# Access Compliance Report

## Public Rights-of-Way

### (Pedestrian Signals)

Intersection ID: N/A	Main Street:	Cross Street: N/A	Location: N/A
ADA ID: EB58E6034013	Signal Type: One Push Button-Non APS	Overall Compliance: No	Severity Score: BTN 1: N/A BTN 2: N/A No BTN: N/A
Codes/Mitigation Info/Possible Solution		Field Measurements/Component Compliance

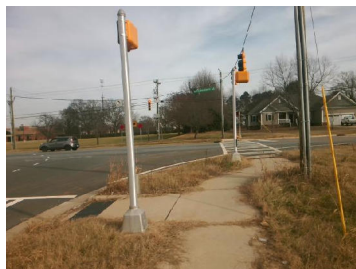
PROW/ADA: TMUTCD 4e.08, R404.1

N/A	B 1 FWD Approach Width (in)	N/A	N/A	B 2 FWD Approach Width (in)	N/A
N/A	B 1 FWD Approach Obstruction?	Yes	N/A	B 2 FWD Approach Obstruction?	N/A
N/A	B 1 FWD Approach Obstruction Dist (in)	3.0	N/A	B 2 FWD Approach ObstructionDist (in)	N/A
N/A	B 1 PARA Approach?	Yes	N/A	B 2 PARA Approach?	N/A
N/A	B 1 PARA Approach Constrained?	Yes	N/A	B 2 PARA Approach Constrained?	N/A
Yes	B 1 PARA Approach Reach (in)	10.0	N/A	B 2 PARA Approach Reach (in)	N/A
Yes	B 1 PARA Approach Width (in)	60.0	N/A	B 2 PARA Approach Width (in)	N/A
N/A	B 1 PARA Approach Obstruction?	Yes	N/A	B 2 PARA Approach Obstruction?	N/A
N/A	B 1 PARA Approach Obstruction Dist (in)	3.0	N/A	B 2 PARA Approach ObstructionDist (in)	N/A
N/A	B 1 Clear Floor Space Slope (%)	4.8	N/A	B 2 Clear Floor Space Slope (%)	N/A
N/A	B 1 Clear Floor Space XSlope (%)	5.7	N/A	B 2 Clear Floor Space XSlope (%)	N/A
N/A	B 1 PAR Slope (%)	N/A	N/A	B 2 PAR Slope (%)	N/A
Yes	B 1 Height (in)	38.0	N/A	B 2 Height (in)	N/A

N/A B 1 Clear Xing Direction?	Yes	N/A B 2 Clear Xing Direction?	N/A
B 1 Crossing Direction	To N	B 2 Crossing Direction	N/A
Yes B 1 DistanceTo XWalk (in)	0.0	N/A B 2 DistanceTo XWalk (in)	N/A
No B 1 DistanceTo Curb (in)	78.0	N/A B 2 DistanceTo Curb (in)	N/A
Yes B 1 Diameter (in)	2.0	N/A B 2 Diameter (in)	N/A

Possible Solutions: Replace Signal Push Button With APS Button on New Post. Remove & Relocate Sign.
